UNITED STATES PATENT AND TRADEMARK OFFICE

APPLICATION NO.	FILING DATE	FIRST NAMED INVENTOR	ATTORNEY DOCKET NO.	CONFIRMATION NO.
10/676,598	10/01/2003	Danny R. Smith JR.	186/41186	7990

Office Action Summary	Application No.	Applicant(s)	
	10/676,598	SMITH ET AL.	
	Examiner	Art Unit	
	Vinh T. Luong	3682

ATTACHMENT 1

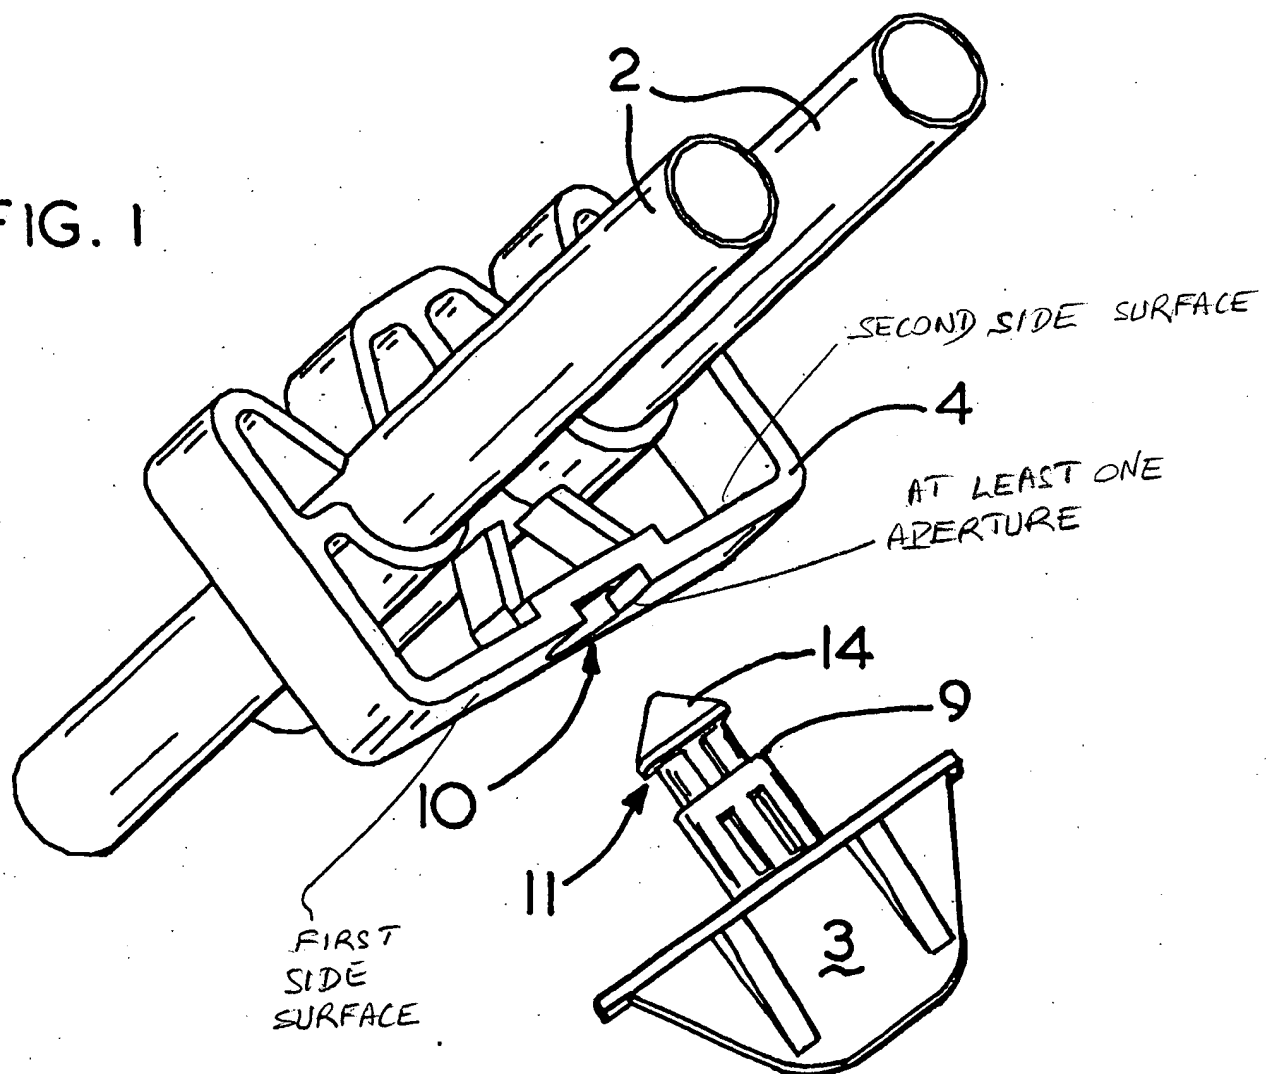
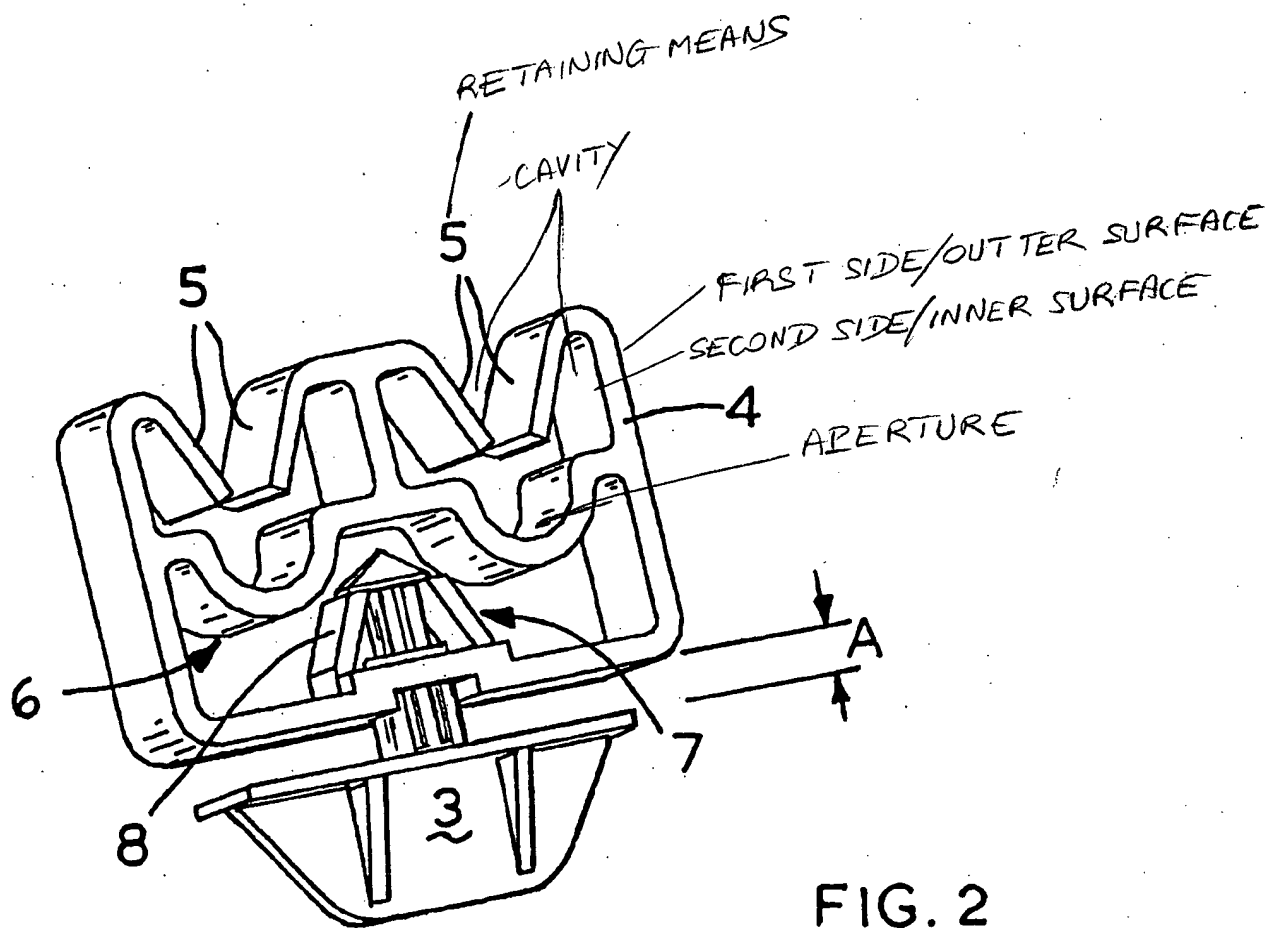
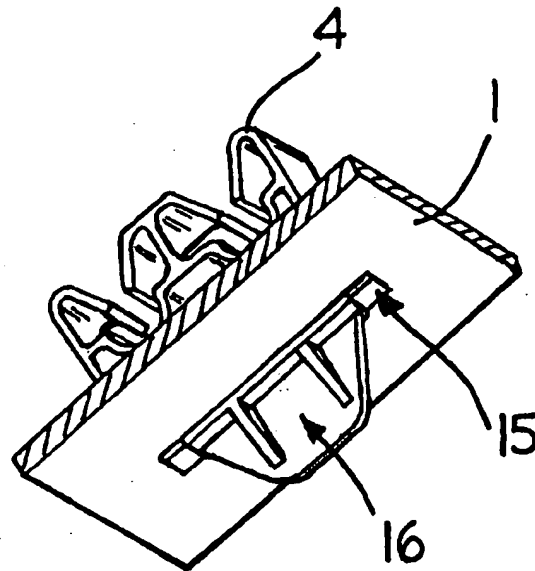
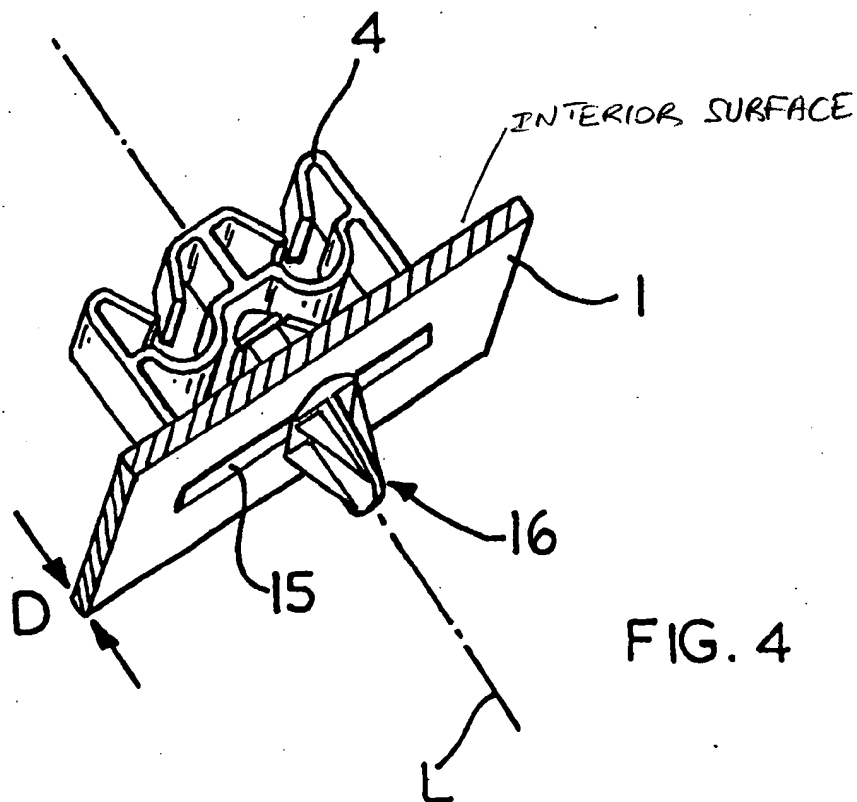
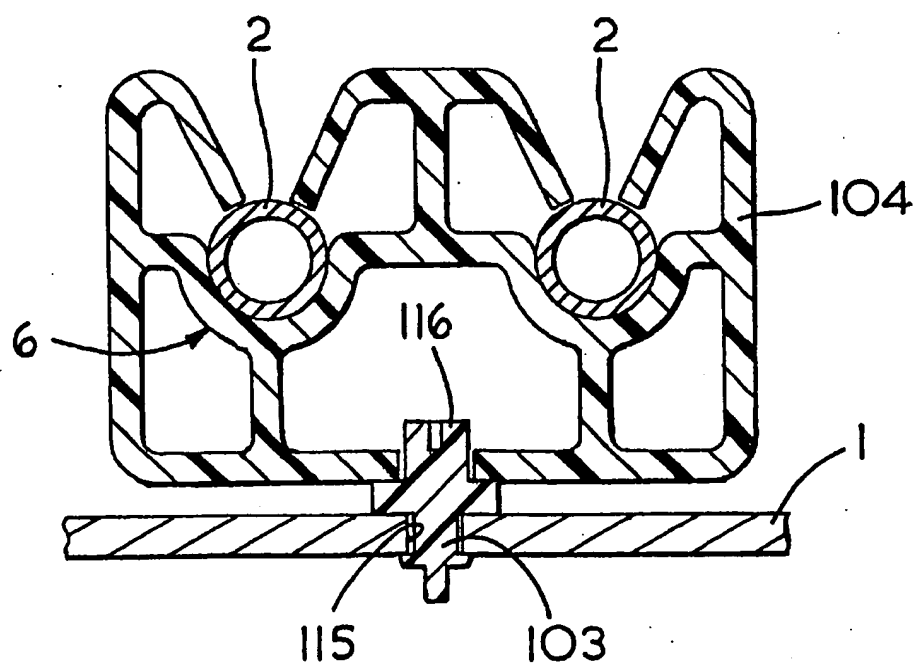
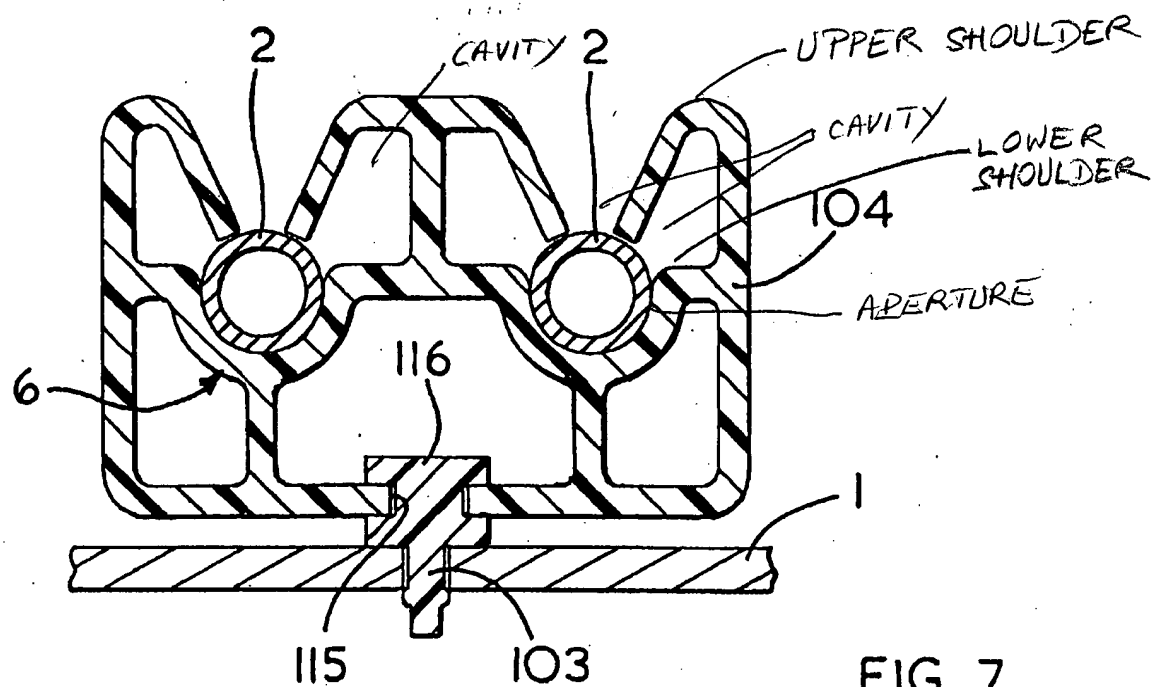
Regarding claim 1, Coudrais teaches an assembly shown in Fig. 1-8 for securing a cable sheath 2 in a cable release system of a product 1, said assembly comprising: a mounting bracket 10 configured to be secured to the product 1, said mounting bracket 10 having an aperture (see Attachment 1 or "Att. 1") therein for receiving the cable sheath 2; and means 5 for selectively retaining the cable sheath 2 within said aperture (Att. 1) of said mounting bracket 10, said retaining means 5 configured to permit adjustment of the cable sheath 2 within said aperture (Att. 1) of said mounting bracket 10.

Regarding claim 2, said aperture of said mounting bracket 10 is sized such that the cable sheath 2 is prohibited from freely moving in a lateral position within said aperture (Att. 1) of said mounting bracket 10.

Regarding claim 3, said mounting bracket 10 has a first side (outer) surface (Fig. 1 of Att.), a second side (inner) surface (Att. 1), and at least one aperture (Fig. 1, Att. 1) which extends through said mounting bracket 10 from said first side surface to said second side surface, said at least one aperture (Att. 1) configured to receive a fastener 3 for securing said mounting bracket 10 to the product 1.

Regarding claim 4, said first side surface (Att. 1) of said mounting bracket 10 is planar

and wherein said first side surface (Att. 1) of said mounting bracket (Att. 1) faces an interior surface (Fig. 4, Att. 1) of the product 1 for securement of said mounting bracket 10 to the product 1.

Regarding claim 5, said mounting bracket 10 has a cavity (defined by fastening structure 5. See Fig. 7 of Att. 1) which extends into said mounting bracket 10 from one of said first and second side surfaces (Att. 1), said cavity (Att. 1) being in communication with said aperture (Fig. 2, Att. 1) of said mounting bracket 10.

Regarding claim 6, said cavity (Att. 1) extends into said mounting bracket 10 from said first side surface (Fig. 2, Att. 1).

Regarding claim 7, said cavity (Att. 1) of said mounting bracket 10 is capable of being wider than said aperture (Att. 1) of said mounting bracket 10 such that said cavity 5 defines an upper shoulder (Fig. 7, Att. 1) and a lower shoulder (Fig. 7, Att. 1).

Regarding claim 8, said retaining means 5 is configured to be inserted into said aperture (Figs. 7 and 8) of said mounting bracket 10 through said cavity in order to retain said cable sheath 2 within said aperture (Fig. 7) of said cable sheath 2, said retaining means 5 being bounded within said cavity (Att.) by said upper and lower shoulders (Att.) such that movement of said cable sheath 2 within said aperture (Att.) is bounded by movement of said retaining means 5.

ATTACHMENT 2

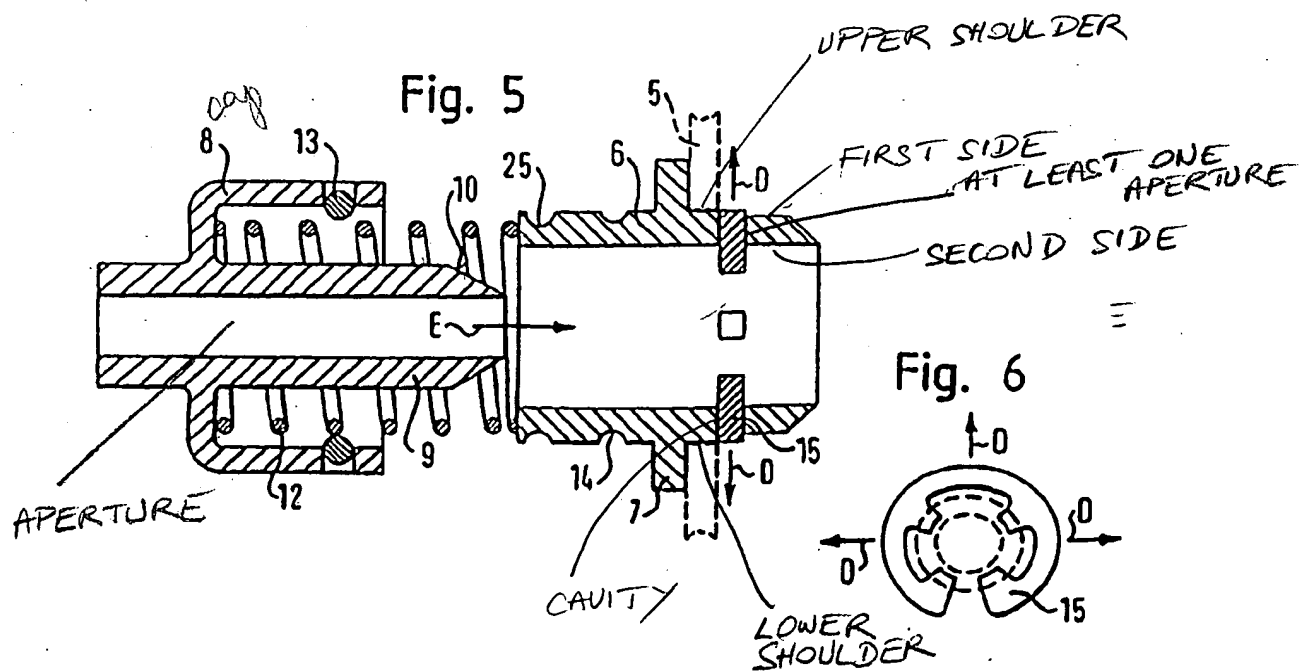
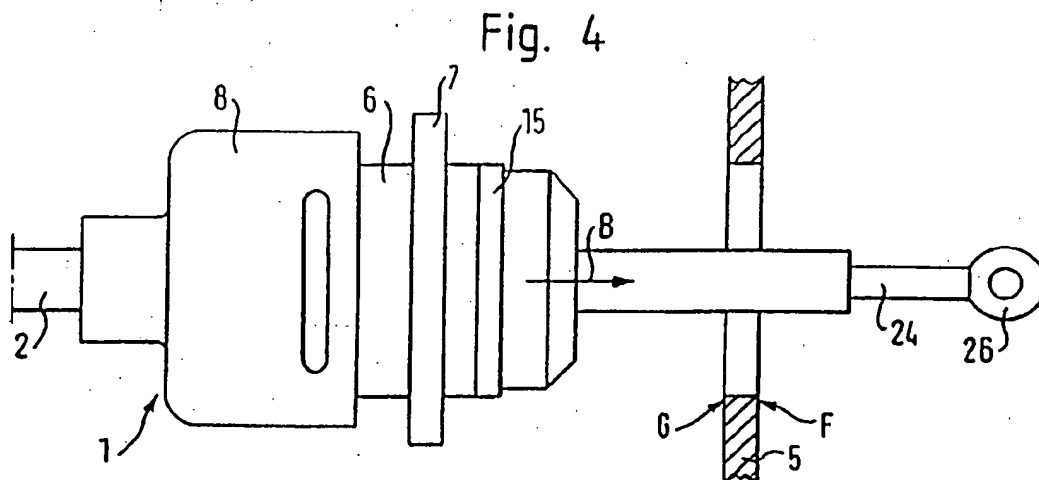
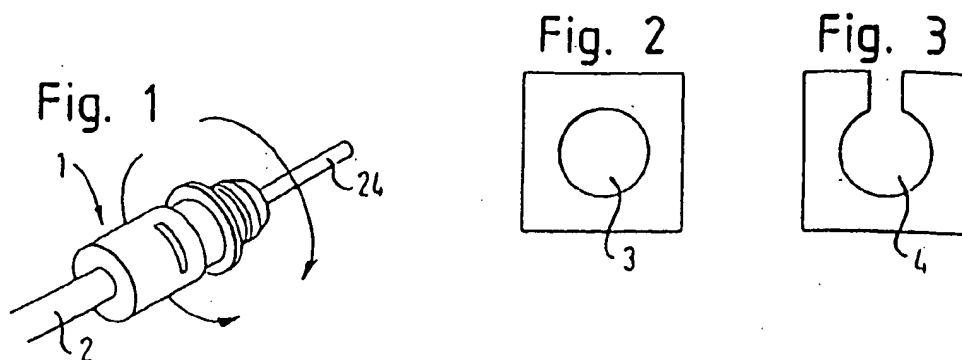
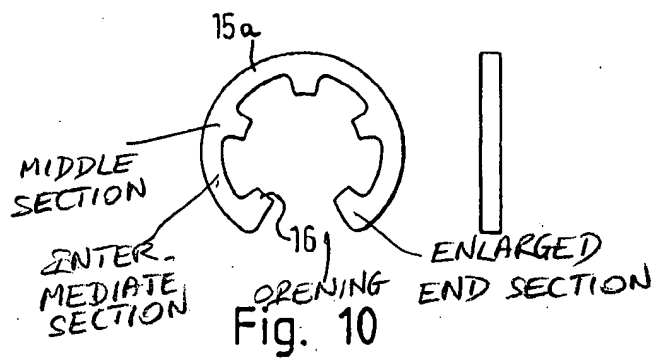
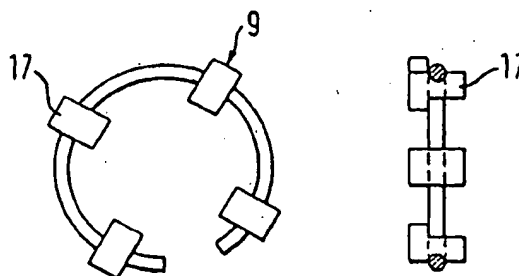
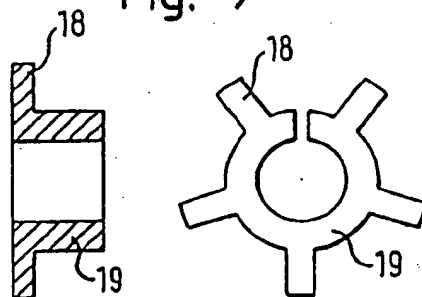
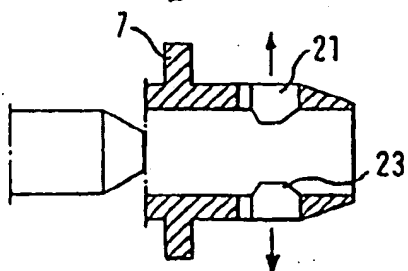
Regarding claim 1, Dona-Contero teaches an assembly shown in Fig. 1-14 for securing a cable sheath 2 in a cable release system of a product 5, said assembly comprising: a mounting bracket 1 configured to be secured to the product 5, said mounting bracket 1 having an aperture (at E in Fig. 5, see Attachment 2 or "Att. 2") therein for receiving the cable sheath 2; and means 15 for selectively retaining the cable sheath 2 within said aperture (E) of said mounting bracket 1, said retaining means 15 configured to permit adjustment of the cable sheath 2 within said aperture (E) of said mounting bracket 1.

Regarding claim 3, said mounting bracket 1 has a first side (outer) surface (Fig. 1 of Att. 2), a second side (inner) surface (Att. 2), and at least one aperture (at 15 in Fig. 5) which extends through said mounting bracket 1 from said first side surface to said second side surface, said at least one aperture (Att. 2) configured to receive a fastener 15 for securing said mounting bracket 1 to the product 5.

Regarding claim 4, said first side surface (Att. 2) of said mounting bracket 1 is planar and wherein said first side surface (Att. 2) of said mounting bracket (Att. 2) faces an interior surface (Att. 2) of the product 1 for securement of said mounting bracket 1 to the product 5.

Regarding claim 5, said mounting bracket 1 has a cavity (Fig. 5, Att. 2) which extends

into said mounting bracket 1 from one of said first and second side surfaces (Att. 2), said cavity (Att. 2) being in communication with said aperture (Fig. 5, Att. 2) of said mounting bracket 1.

Regarding claim 6, said cavity (Att. 2) extends into said mounting bracket 1 from said first side surface (Fig. 2, Att. 2).

Regarding claim 7, said cavity (Att. 2) of said mounting bracket 1 is capable of being wider than said aperture (Fig. 6, Att. 2) of said mounting bracket 1 such that said cavity (Att. 2) defines an upper shoulder (Att. 2) and a lower shoulder (Att. 2).

Regarding claim 8, said retaining means 15 is configured to be inserted into said aperture (Att. 2) of said mounting bracket 1 through said cavity (Att.) in order to retain said cable sheath 2 within said aperture (Att. 2) of said cable sheath 2, said retaining means 15 being bounded within said cavity (Att. 2, Fig. 5) by said upper and lower shoulders (Att.) such that movement of said cable sheath 2 within said aperture (Att. 2) is bounded by movement of said retaining means 15.

Regarding claims 11 and 15, said retaining ring 15 includes a middle section (Fig. 7, Att. 2), a pair of enlarged end sections (Att. 2), and a pair of intermediate sections (Att. 2) which interconnect said enlarged end sections (Att. 2) with said middle section (Att. 2), said enlarged end portions (Att. 2) being spaced from one another to define an opening (Att. 2) located opposite said middle section, said opening being configured to accept the cable sheath 2.
